Single Deck Block Diagram
(one of three)

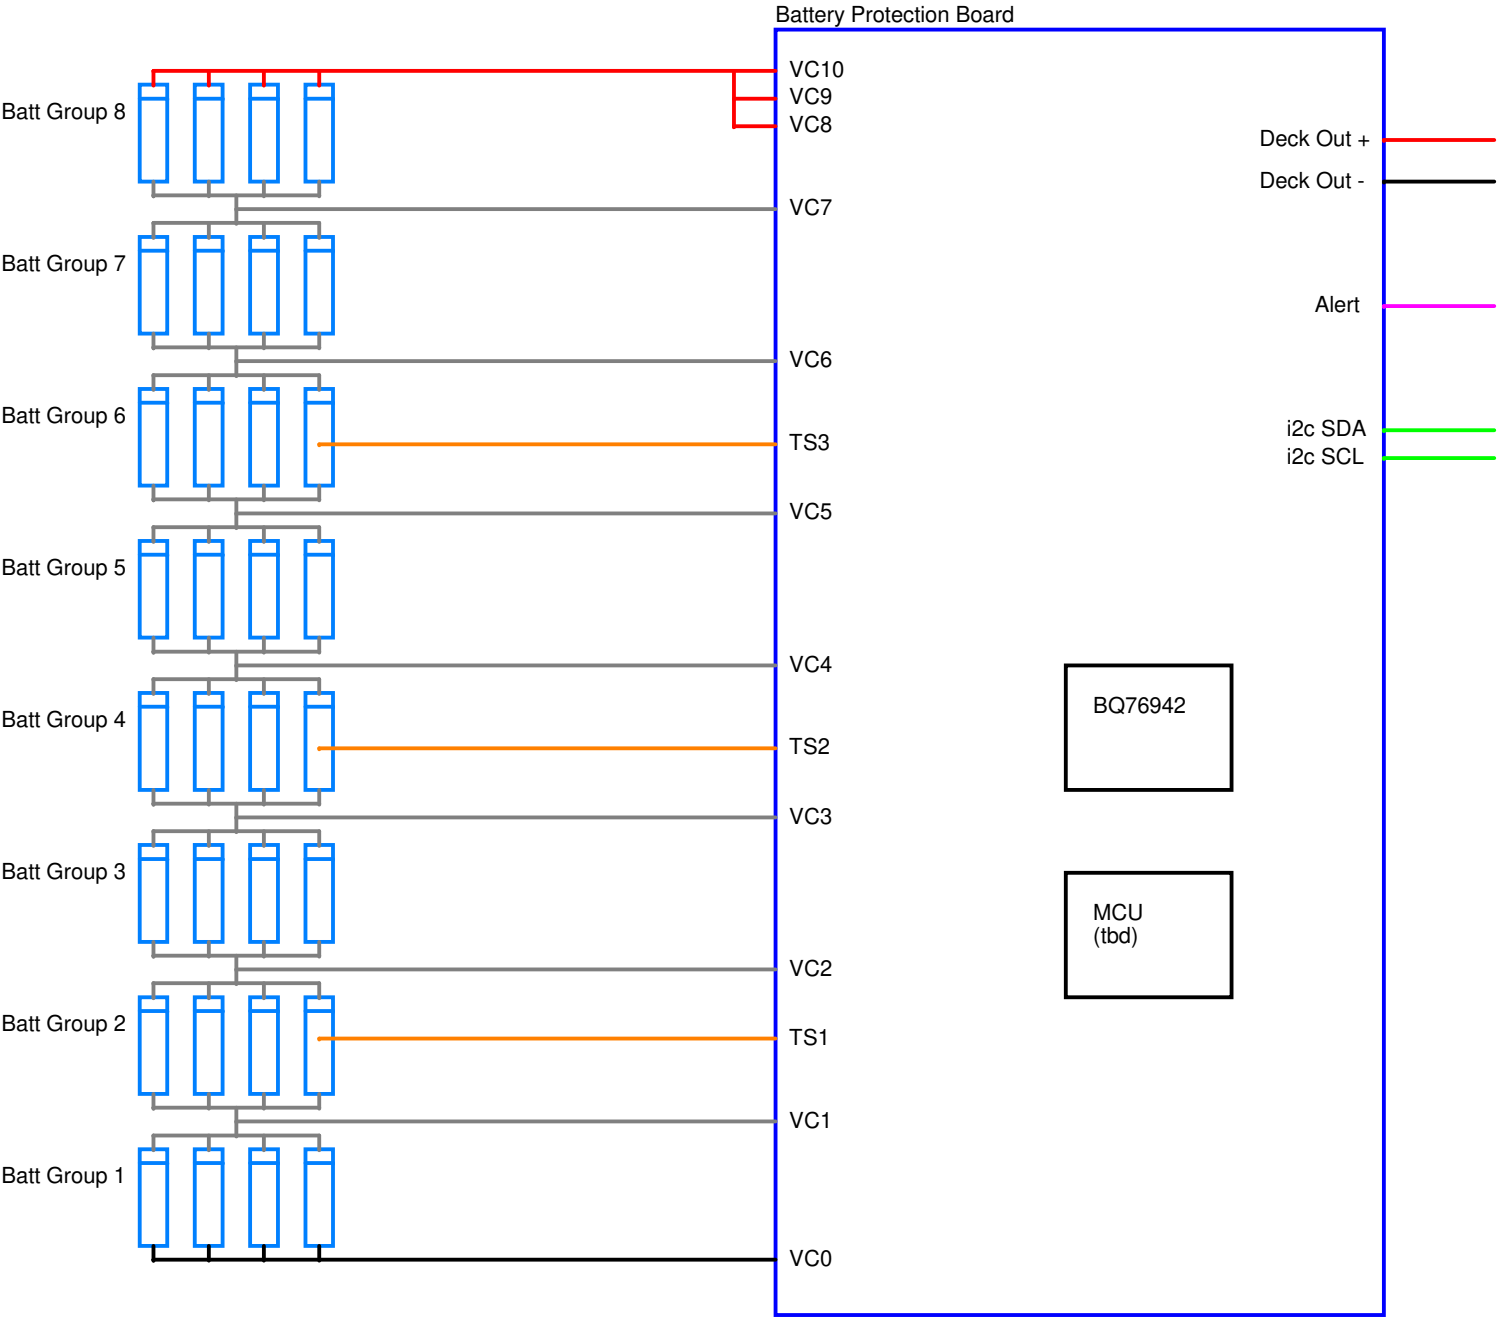
Notes:
Does Alert need to go off board or only to the board level MCU?
Drawing only shows the 3 native thermistor inputs (can add more)
